Response from David Walker

My name is David Walker and I live with my family at 8 Lightcliff Ave, Lindfield. We adjoin the proposed development to the east and our home is a heritage property in a heritage conservation area. I've lived here with my family for around 5 years. We were attracted to the area and the property by its natural environment and privacy and we like where we live very much.

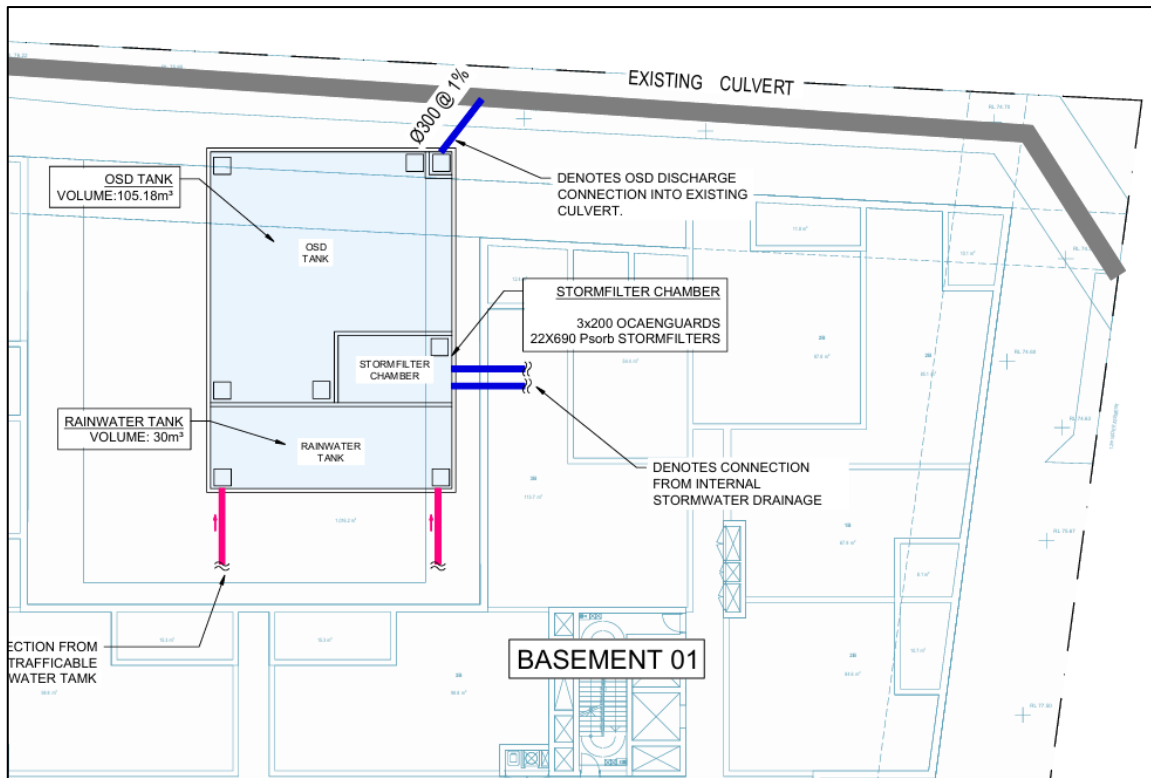
Section 11 of the SEARs requires the applicant to outline the proposed drainage design. I'm glad to see that the design in the applicant's Appendix 21: Stormwater Drainage Plan incorporates a detention tank. With the removal of significant areas or deep soil being replaced by hard surfaces, run off from the site will be significant. However, further details would be appreciated, as downstream of the proposed development is currently in a flood zone (see Council flood maps, also shown in the applicant's Appendix 22: Flood Impact Risk Assessment). Therefore any additional water exacerbates this risk.

For example, will the tank be empty when it's not raining, and what rate will water exit the tank?
